From: Keller, Kevin <Kevin.Keller@hdrinc.com>
Sent: Wednesday, May 20, 2020 11:42 AM
To: Wayland, Joshua
Cc: 10145616_7CountyCoalitionUBR TO1
Subject: UBRY - APE Adjustment - WD
Attachments: 20191122 7-County UBRY Wells Draw APE For STB FINAL - Tribe Adjustment.kmz

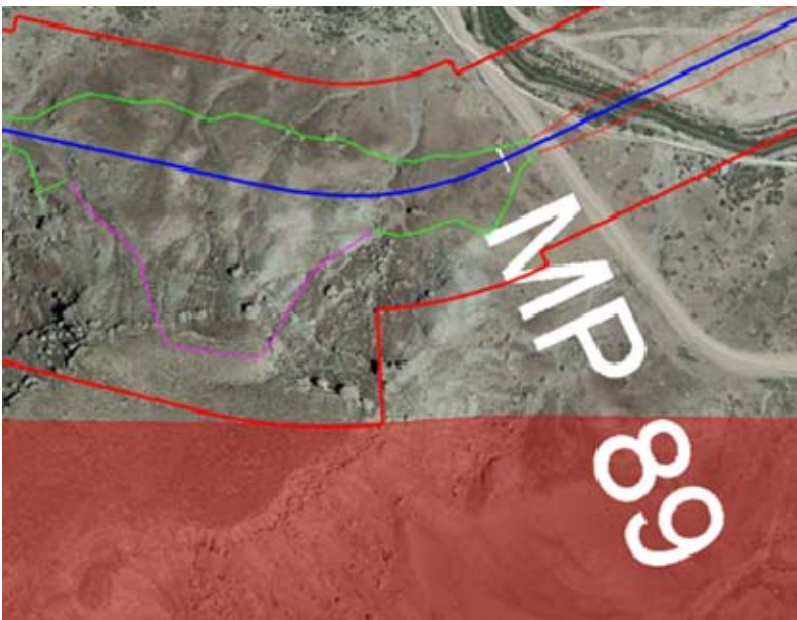
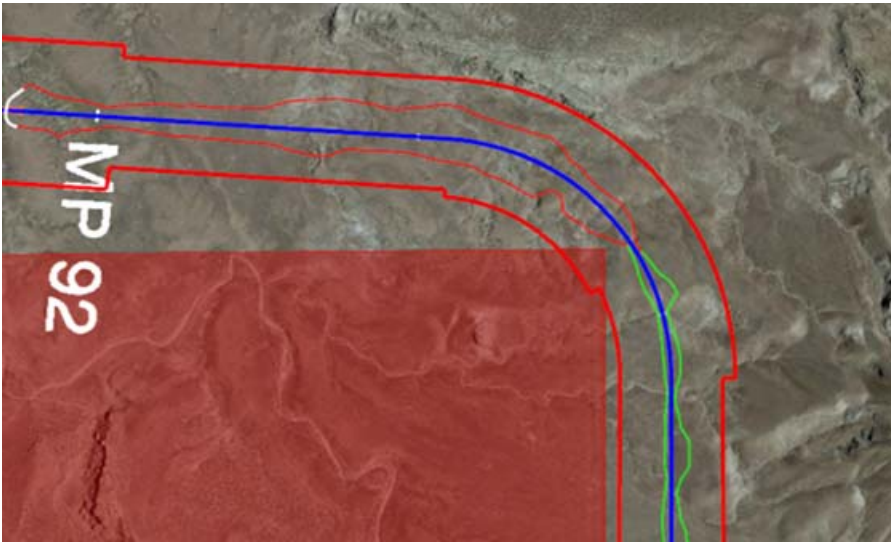
Just so you know, we've adjusted the APE on the Wells Draw alignment alternative to NOT be on tribal land, as the two images below showed. The corrected alignment is attached. The overlap was caused by the imperfect translation from design files to kmz conversion.

Yes, see images below, they were both around Leland Bench.

We have updated the APE to not show any overlap on tribal lands in the KMZ. There was a bit of overlap due to the imperfect translation from design files to kmz conversion, but it is fixed now in the attached. Since Josh said he handled it on his side, not sure this needs to be transmitted to anyone.
